# Data Request Response #1

# Corby Battery Energy Storage System Project (24-OPT-05)

April 2025

This Data Request Response #1 to North Bay Interconnect, LLC and Corby Energy Storage, LLC's (Applicant)<sup>1</sup> Opt-in Application (Application) for the Corby Battery Energy Storage System Project (Project) (24-OPT-05), responds to comments that California Energy Commission (CEC) Staff have made as a result of their data adequacy review of the Application, as documented in their Determination of Incomplete Application and Request for Information letter dated December 9, 2024. The intention of this supplement is to provide all additional information necessary for Staff to find that the Application contains adequate data to begin an Opt-in Renewables site certification proceeding under California Code of Regulations, Title 20, Section 1877, and Public Resources Code, Section 25545, for the technical areas included in the submittal.

# APPENDIX 8-A: SUBSTATION DRAWINGS (REPLACES FIGURES 3-5A-C AND 3-6)

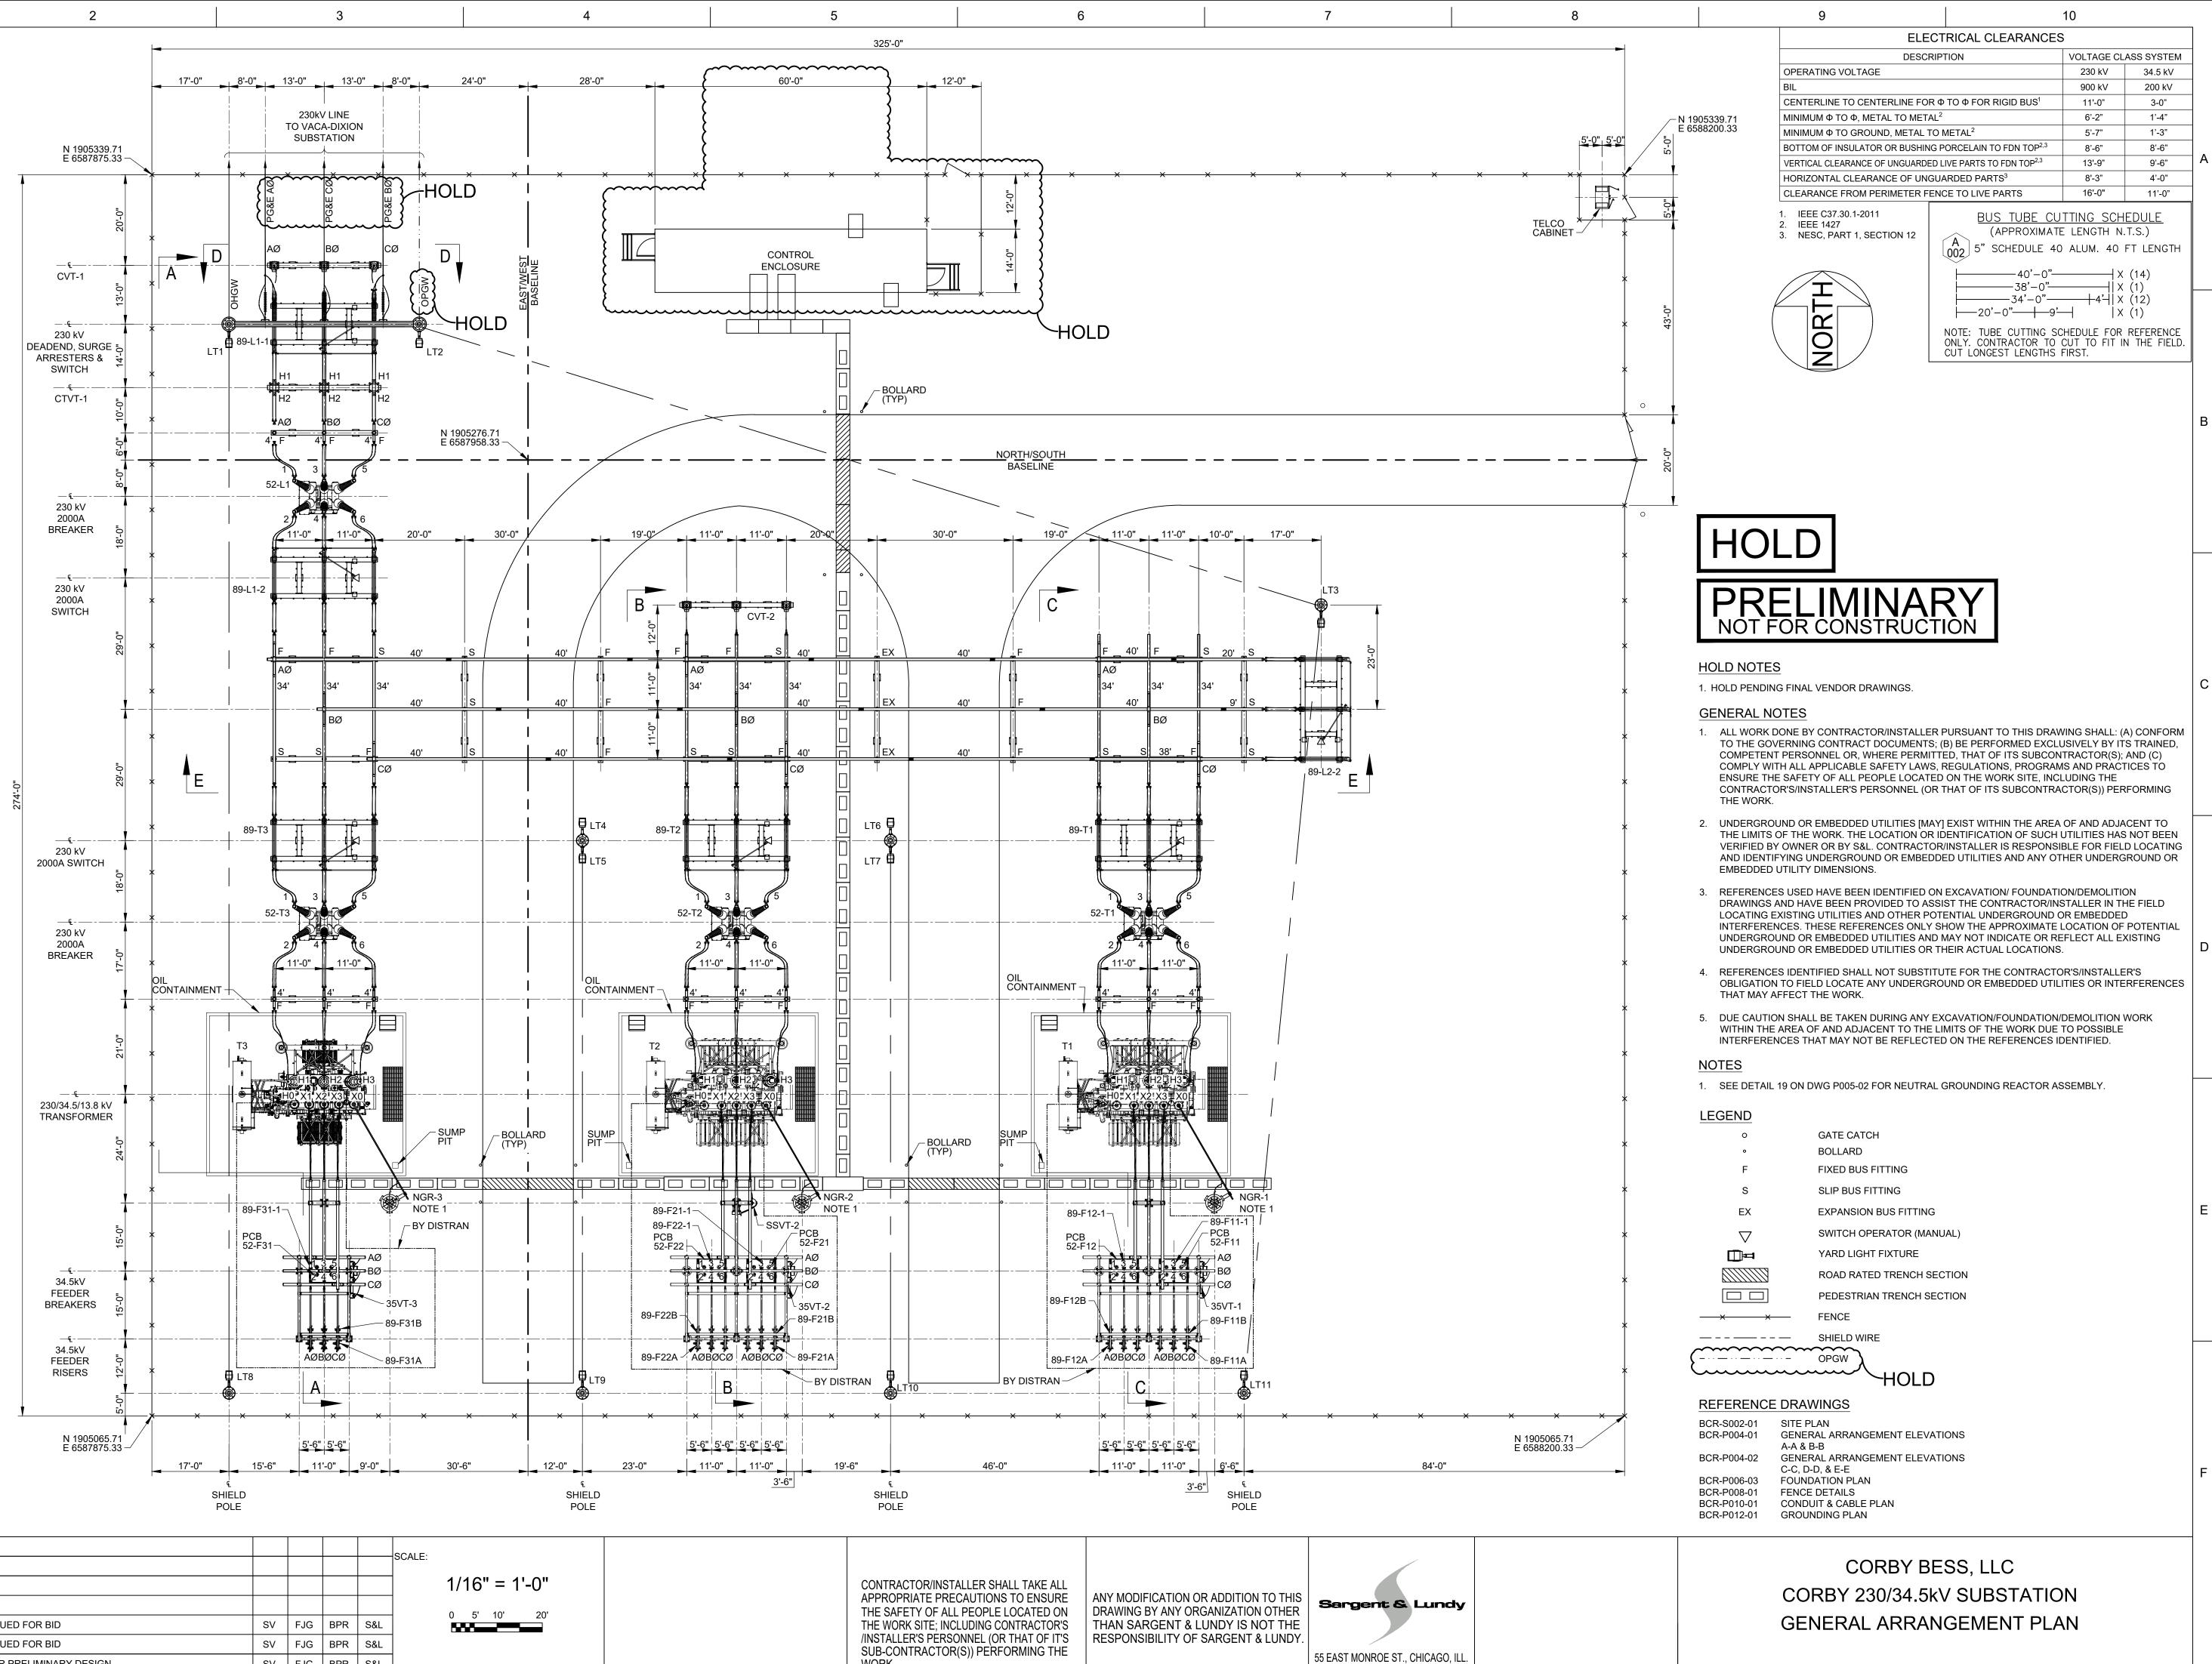
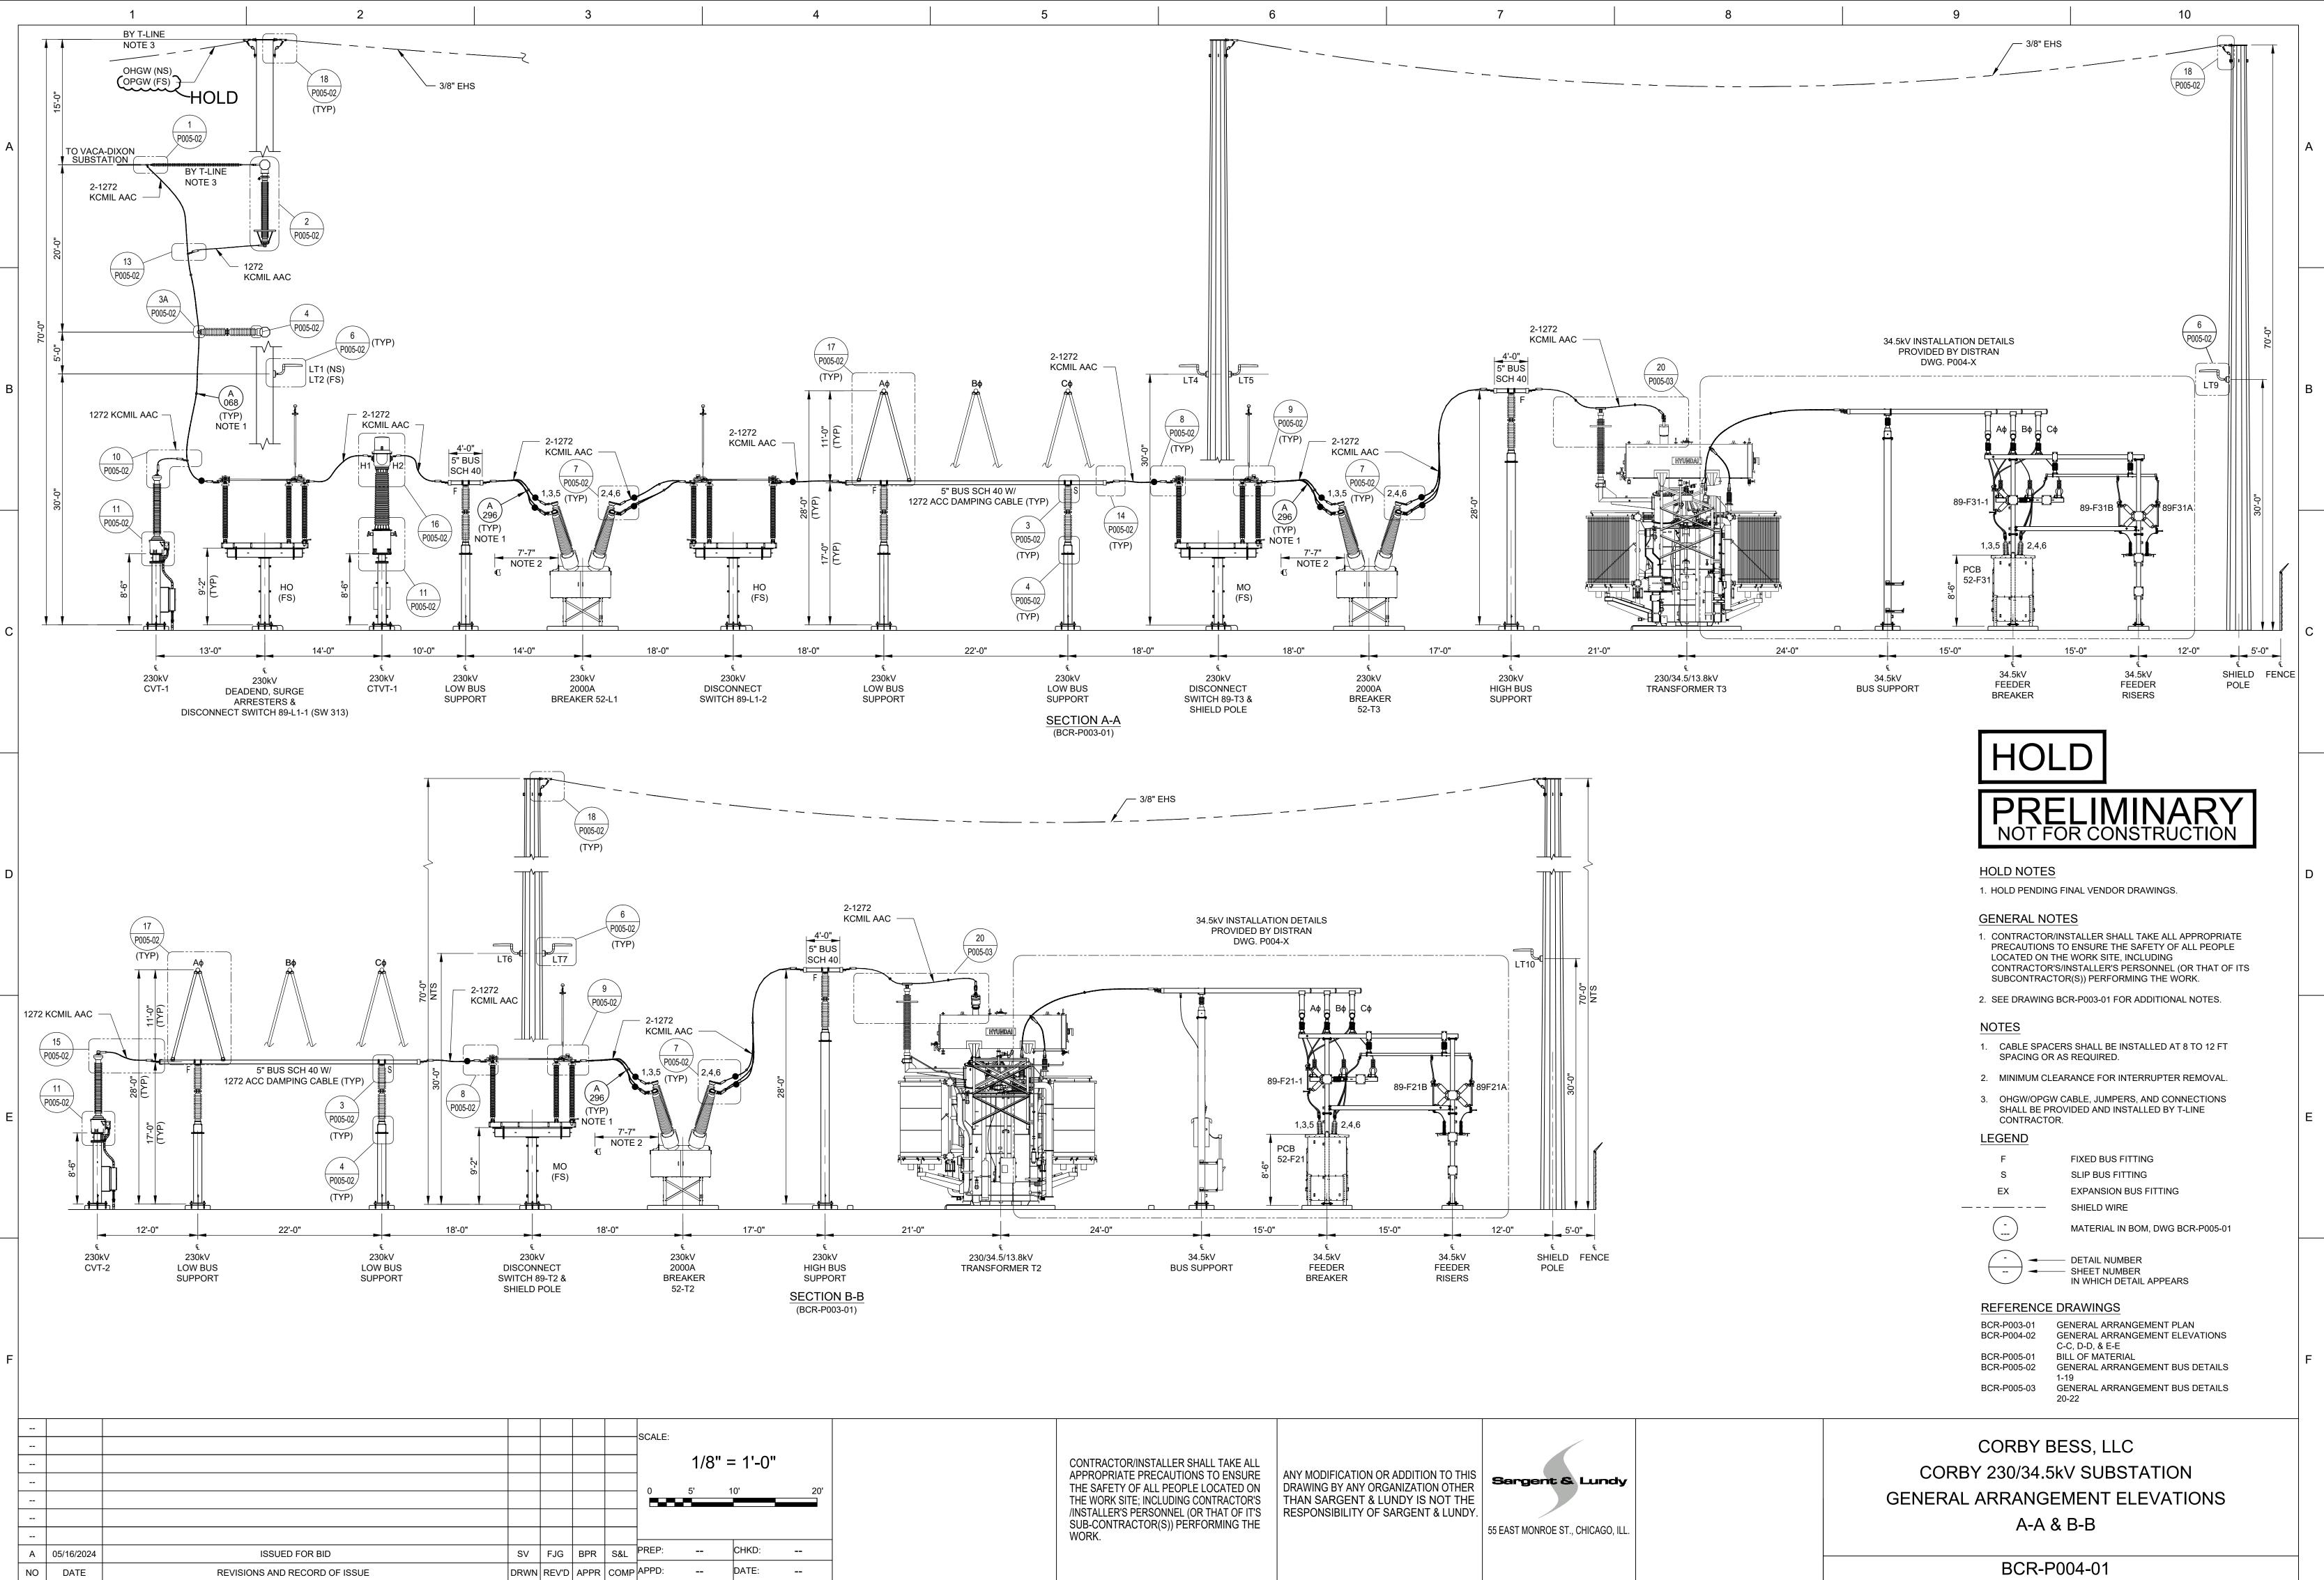
**DR TSD-1.** Please resubmit Figures 3-5a, 3-5b, 3-5c and 3-6. These figures submitted are not legible. Show all equipment ratings including the bay arrangement of the circuit breaker, disconnection switches, buses, transformers, and other equipment that would be required for the project interconnection to the proposed switchyard.

**Response:** The process of converting the original engineering drawings into Figures 3-5a, 3-5b, 3-5c, and 3-6 resulted in reduced resolution; therefore, the original engineering drawings are provided in Appendix 8-A to ensure improved resolution.
